18380 NANTZ RD

AUTHORIZATION FOR WASTEWATER SYSTEM CONSTRUCTION
VOID SIXTY (60) MONTHS FROM DATE OF ISSUANCE

PERMIT NO: 11082
PARCEL NO: 001-051-16

SOIL/SITE EVALUATION
for ON-SITE WASTEWATER SYSTEM

PROPOSED PLOT PLAN

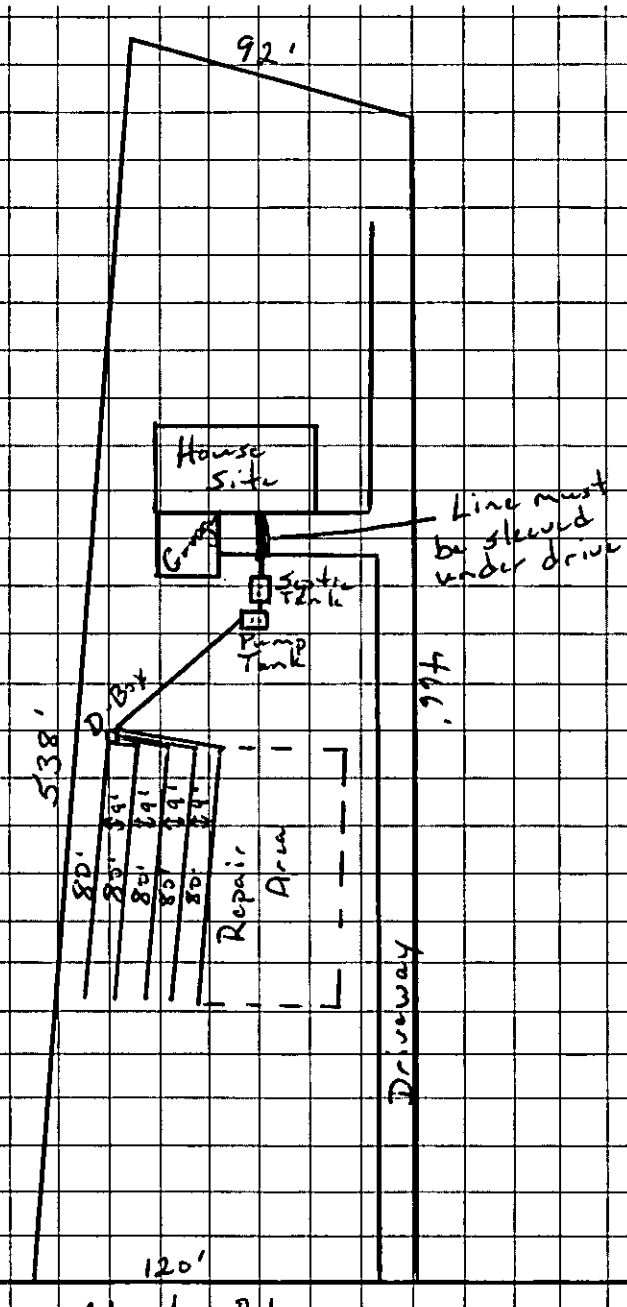
1) Outer boundries not drawn to scale.
2) Scale 1" = 60'
3) Keep lines level and on contour if possible
4) Keep trenches shallow - 20" maximum.
5) Keep all parts of septic system at least the minimum distance from the following:
   A) Well - 100 ft
   B) Foundation - 5 ft.
   C) Property Line - 10 ft.
6) Terrace must be leveled.

Site Plan

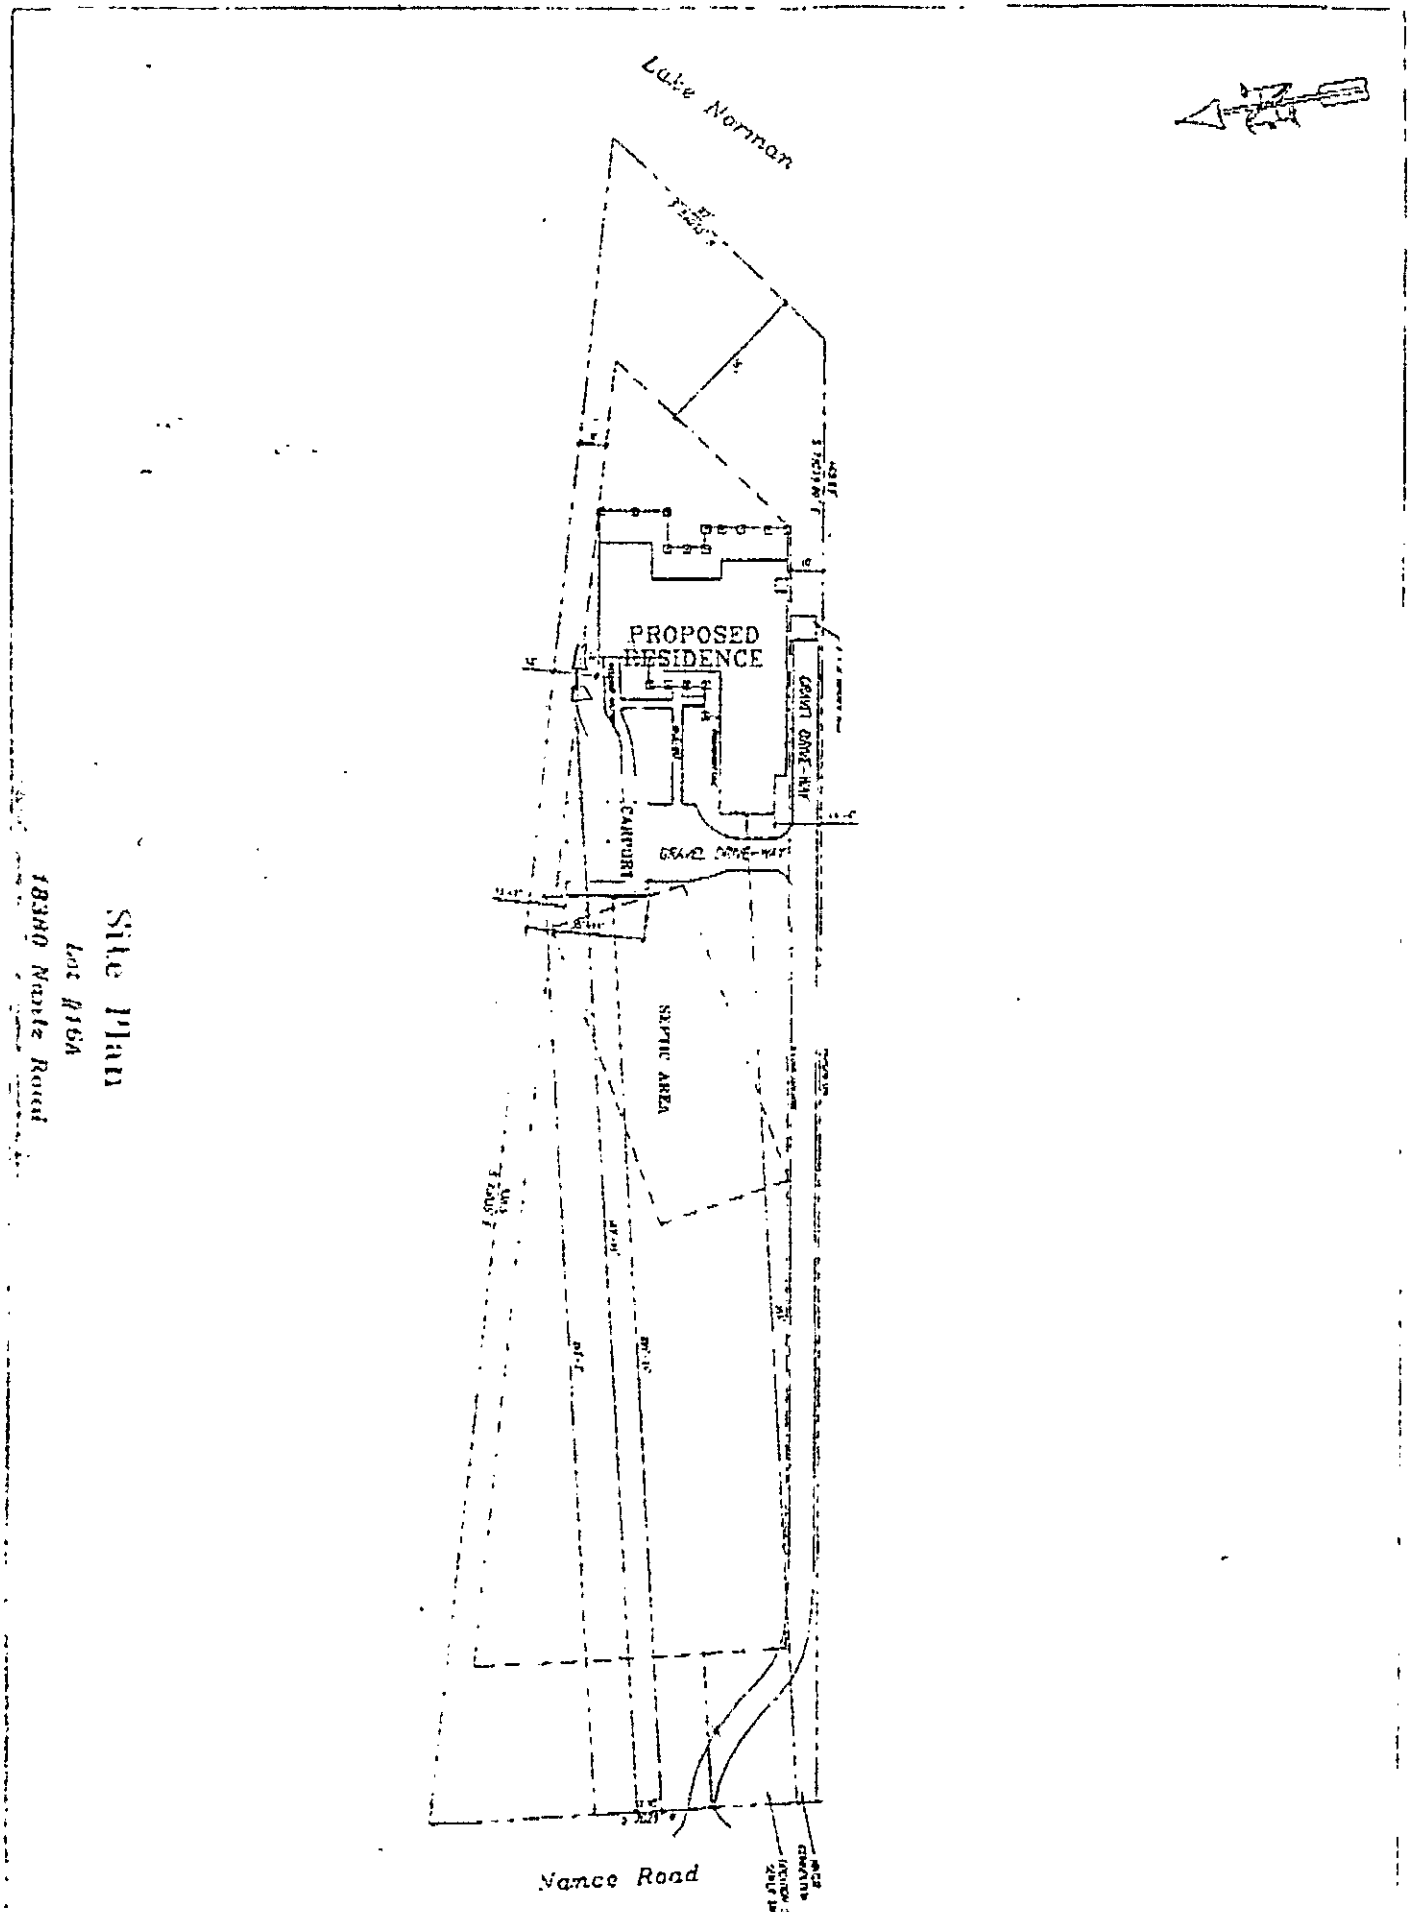
HERE IS THE NEW SITE PLAN FOR THE TAYLOR RESIDENCE AT LAKE NORMAN. THE HOUSE AND CARPORT HAVE BEEN STAKED AND I JUST WANTED TO SEE IF WE COULD MEET TO SEE IF WE ARE OK WITH THE SEPTIC FIELD HERE.

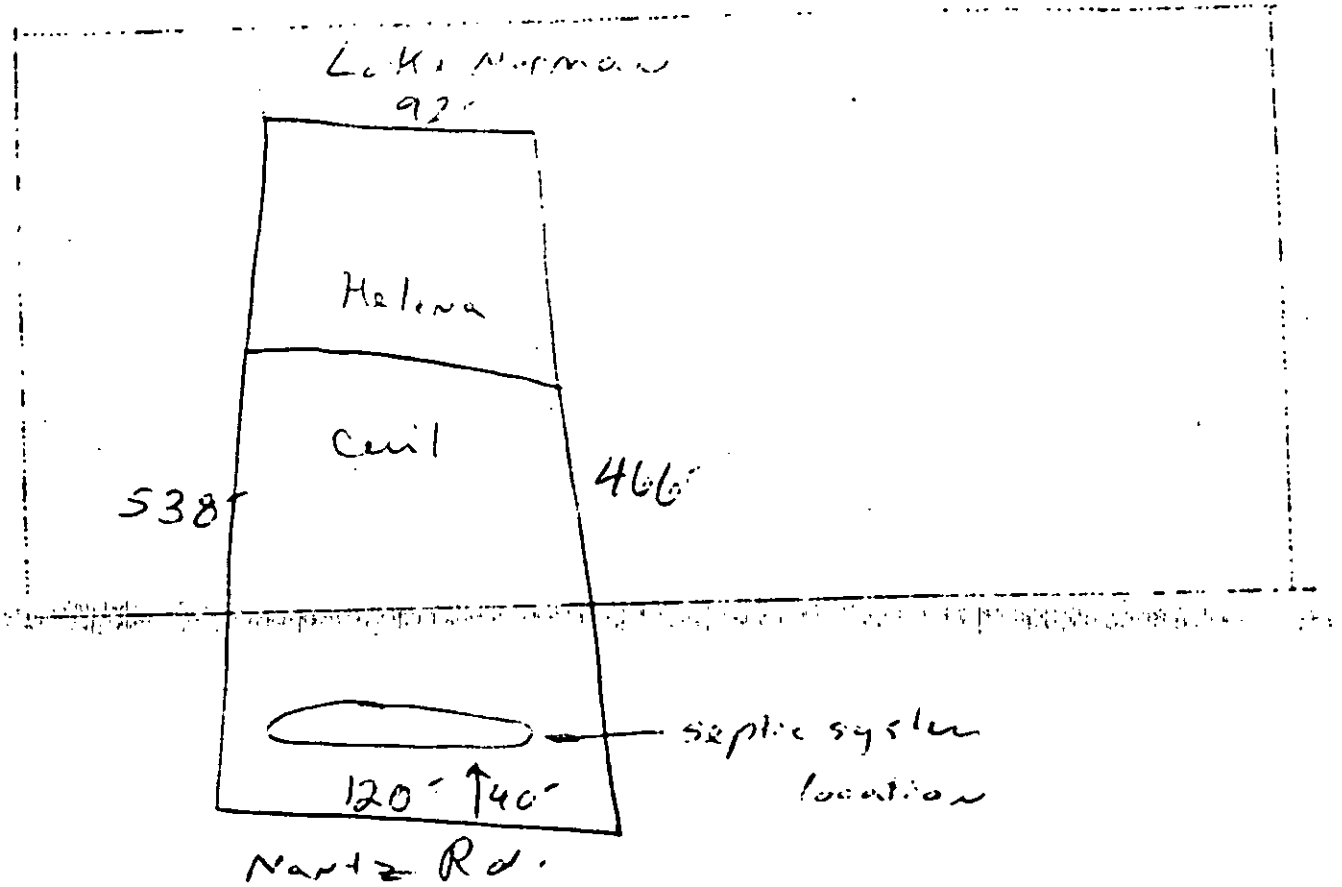
Recommendations Based on this investigation, the lot is recommended for approval for installation of a septic tank system. System design should be based on a percolation rate of 60 min/in. and should be placed in the area of ~~B~~ Cecil soils.
